Response to Comments on Tentative WDRs for Campbell Soup Supply Company, LLC

Comments were submitted by Campbells Soup Supply Company, LLC, on 18 April 2019

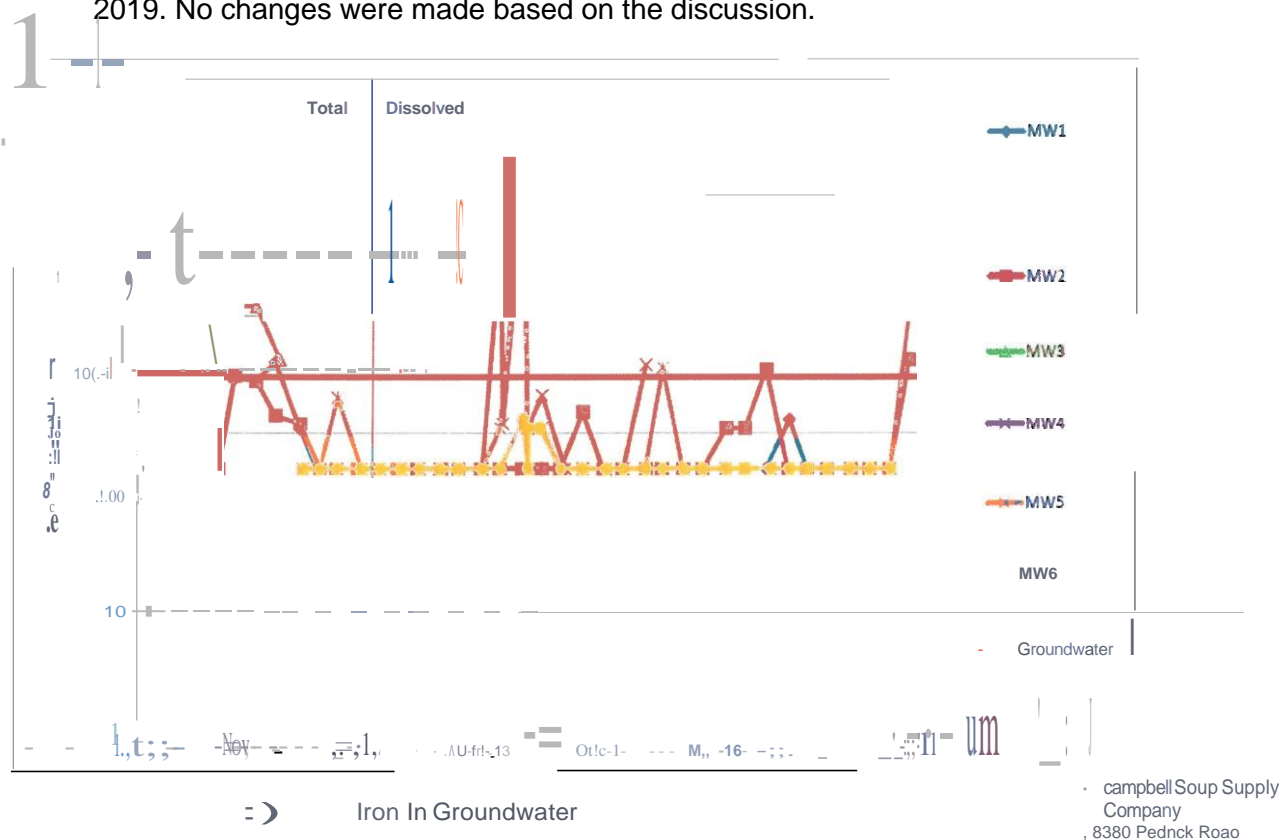
8. (Pages #7-9, Sec. 37-38) In the column of the tables "Concentration Protective of Beneficial Use" there are levels listed that reference many different MCLs or Water Quality Goals (see reference below). Our discharges for EC since the RO units were installed in August of 2011 average out to 638 µmhos/cm, with the highest single detection at 870 µmhos/cm. This average is well below the Secondary Maximum Contaminant Level of 900 µmhos/cm. The levels measured in the downgradient monitoring wells are consistently above the Secondary MCL, most likely due to legacy salts from operation of the ion-exchange water softeners prior to August of 2011. Boron levels in the discharge over that same time period average out to 0.54 mg/L, which is

below the lowest agricultural water quality goal of 0.7 mg/L. Downgradient monitoring wells #4 and #1 are consistently above the 0.7 mg/L, while #2 occasionally exceeds that level (although with less frequency in recent years). The Boron concentrations in source water average 0.55 mg/L, so tomato processing doesn't seem to contribute to the levels of Boron in the wastewater. Our concern, in both of these cases, is that we may violate groundwater limitations due to legacy conditions or conditions that don't seem to be tied to the levels of constituents in our recent wastewater discharges.

Response: Issue was discussed during a conference call on 16 April 2019 with the Discharger. No changes were made based on the discussions.

Manganese in Groundwater
Campbell Soup Supply Company
800 Pedrick Road
Piquette, MI 48679

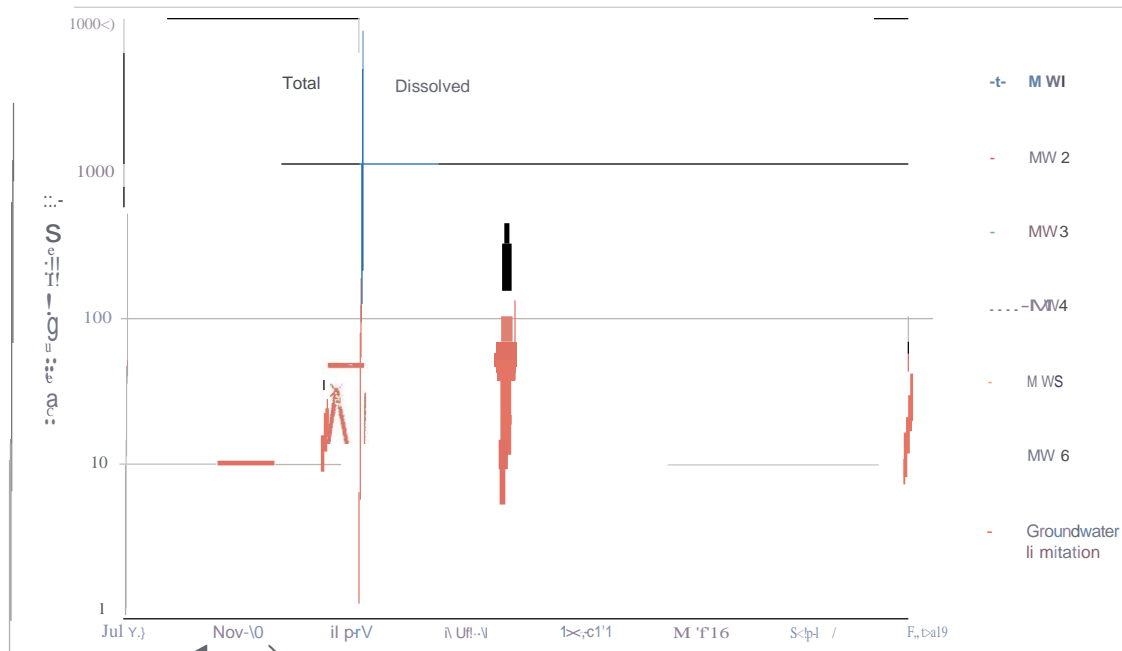
10. (Page #13 Sec. 64) Look at methodology behind the average concentrations in the table. The iron and manganese average levels obscure the fact that the measurements are a mix of many "no detects" and some moderate to extremely high spikes. These occur in both upgradient and downgradient wells and have tended to take place during times when no wastewater application is taking place on the property (December and March). Boron is also not included in the table as a constituent of concern, even though it is monitored and regulated as one.

Response: Issue was discussed during a conference call with the Discharger on 16 April 2019. No changes were made based on the discussion.

Groundwater Nitrate-N
Campbell Soup Supply Company
800 Pedrick Road
Piquette, MI 48679

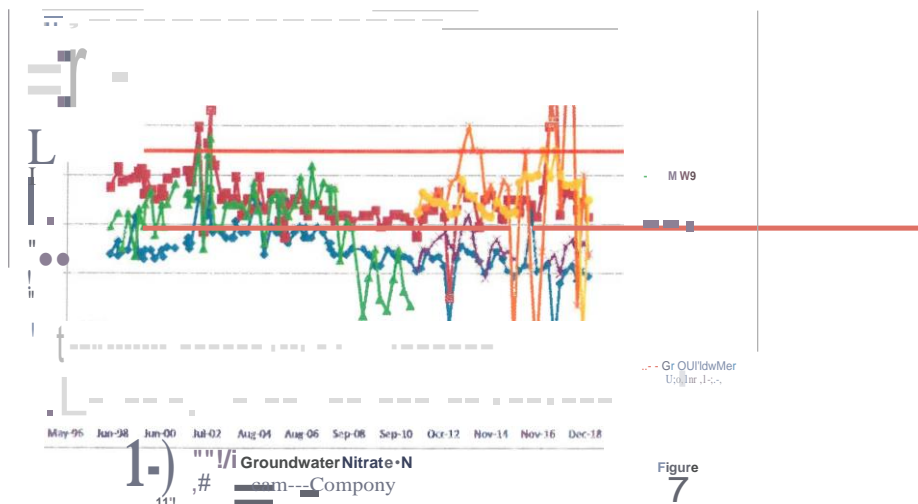
11. (Page #15 Sec. b. Nitrate) Concentrations of nitrate in the downgradient wells MW1 and MW4 are typically much lower than the upgradient wells rather than being "equivalent", although upgradient well MW5 is highly variable in nitrate levels measured. Downgradient well MW2 does have equivalent levels of nitrate as upgradient wells. The location of MW2 on the southern border of the LAA and the groundwater flow direction (from west to east), may allow practices used on agricultural land to the south and southwest to influence the nitrate levels measured, rather than only measure the impact of wastewater discharges from the plant.

Response: Text was clarified.

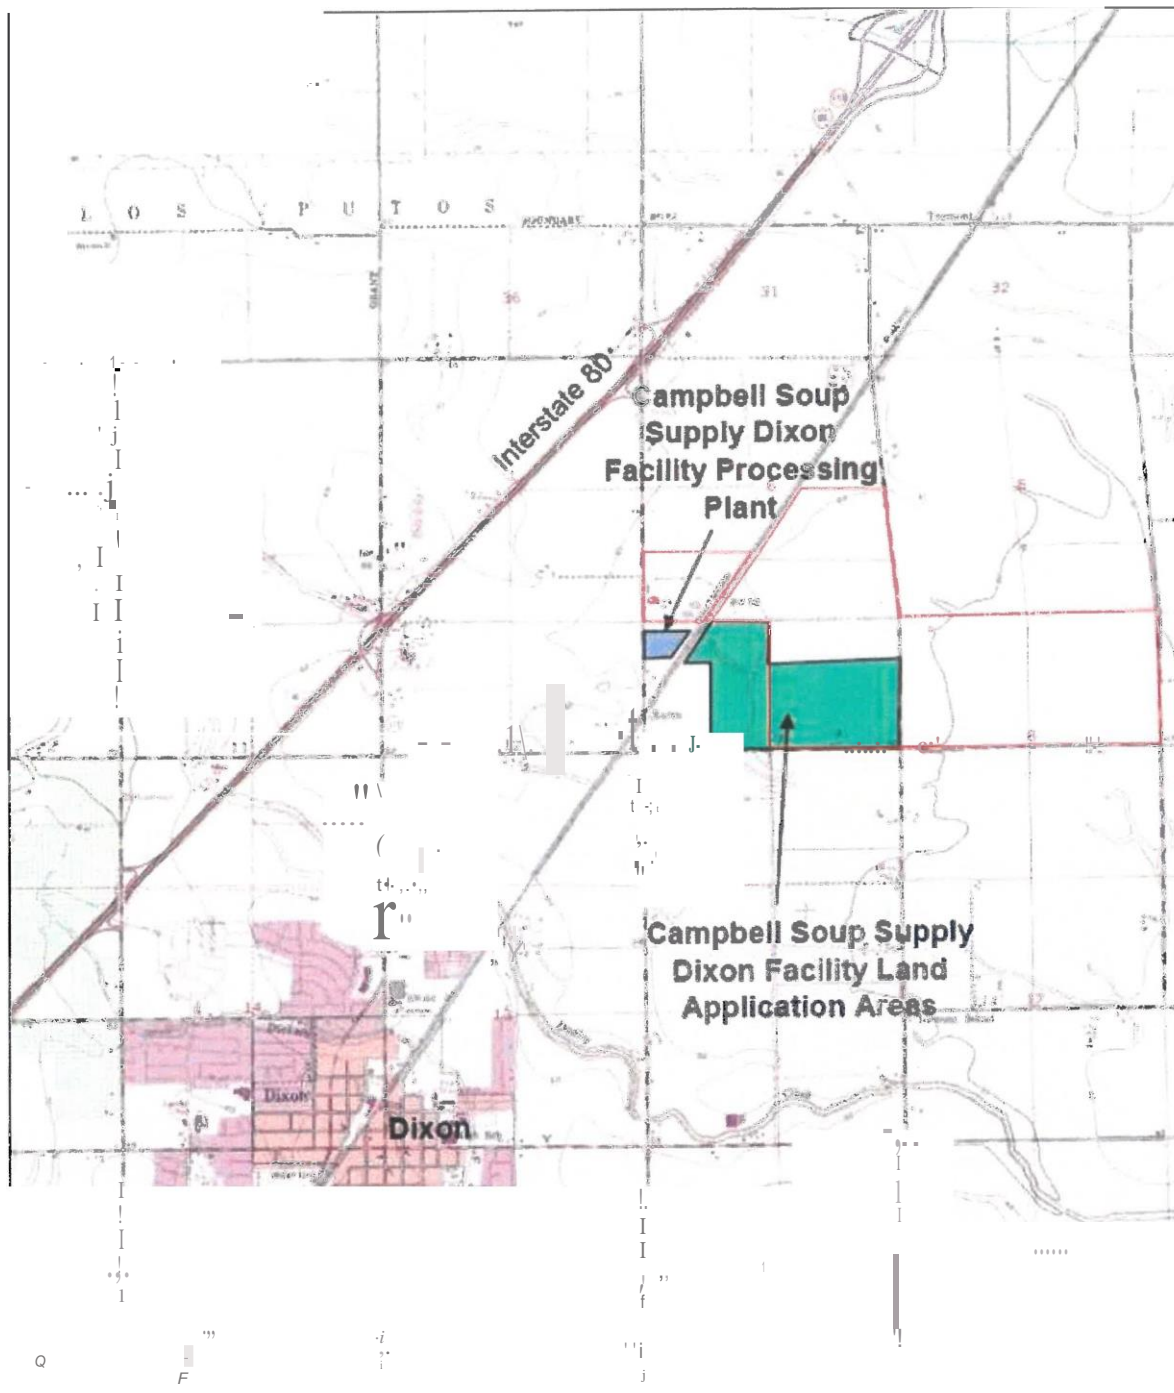
23. (Attachment A) The outlines of the facility and land application areas on the site map are not correct. The correct boundaries are shown in red on the diagram below.

Response: Attachment A was corrected.
